H-11161

## DESCRIPTIVE REPORT

General Locality ..... NORTHERN CLARENCE STRAIT

Sublocality ..... SHRUBBY ISLAND TO BLASHKE ISLAND

**Figure 8 Comparison of Contours-1**

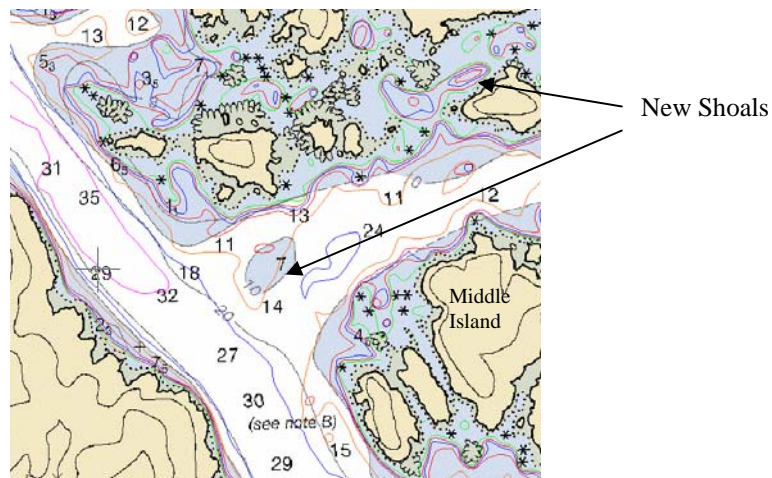
- H11161 reveals that the 10-fathom contour located northwest of Middle Island as<sup>52</sup> migrated to the south and new shoals are present.<sup>53</sup>

53 Concur with clarification. While new shoals are present, the upper arrow in Figure 8 points to a hole, not a shoal.
